TECHNICAL INFORMATION

60787

Subject ▶ Modifications of Parts Concerning "Motor Head Lock" Function

For Models ▶ BLS820, LS800D

1) Addition of Stop Ring E-6

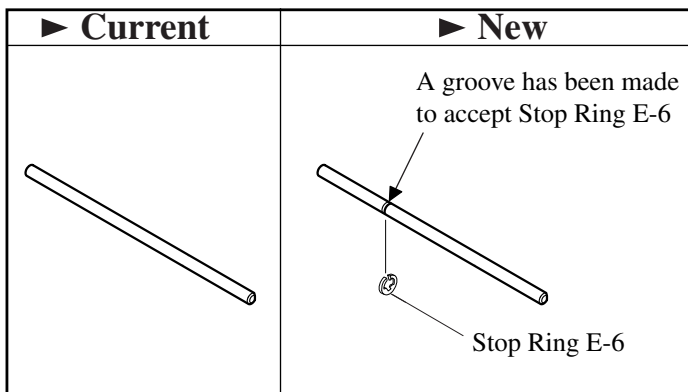
Description ▶ For smoother action of Rod 8 when locking/unlocking motor head;
1) Stop Ring E-6 has been added.
2) Rod 8 has been modified to accept Stop Ring E-6. (Its part number remains unchanged.)
3) A rib to support Rod 8 has been made on Blade Case. (Its part number remains unchanged.)
